Noise from (panoramic) roof in area of C-pillars at high speeds (75+mph)

| Topic number | LI65.10-P-074275 |
| Function group | 65.10 - Roof paneling |
| Validity | Model series 223 with SA code 413 |

| Attachments | |
|---|-------------|
| Bild I.jpg | |

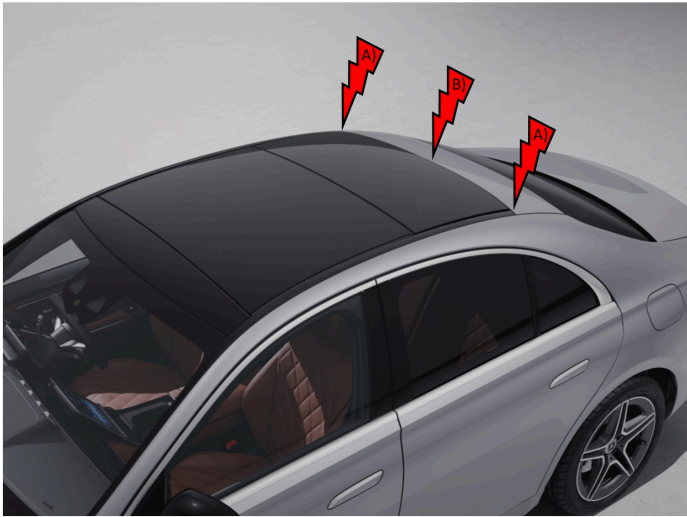
A) Wind noise in area of rear edge of rear fixed element of panoramic sliding sunroof (EPC item 78/150/550) at speeds over approx. 75mph (Picture I)

B) Wind noise in area of rear edge of rear fixed element of panoramic sliding sunroof (EPC item 78/150/550) at speeds over approx. 120mph (Picture I)

| Attachments | |
|--|-------------|
| Bild II.jpg  | |

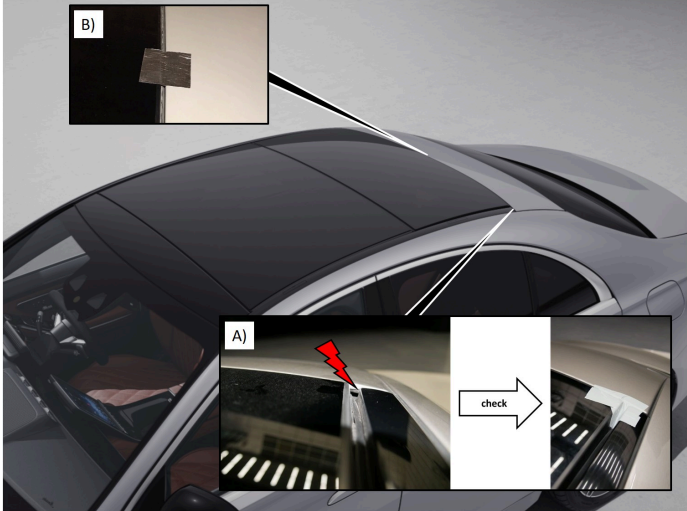
Identification of source of noise by masking off of (Picture II):

A) Joint between drip rail (EPC item 69/060/250), rear roof paneling (EPC item 65/015/300) and rear fixed element of panoramic sliding sunroof (EPC item 78/150/550)

B) Joint between sealing lip of rear roof paneling (EPC item 65/015/310) and rear fixed element of panoramic sliding sunroof (EPC item 78/150/550), with approx. 5 cm-long adhesive strip - CAUTION: Sealing lip is very sensitive, do not damage!
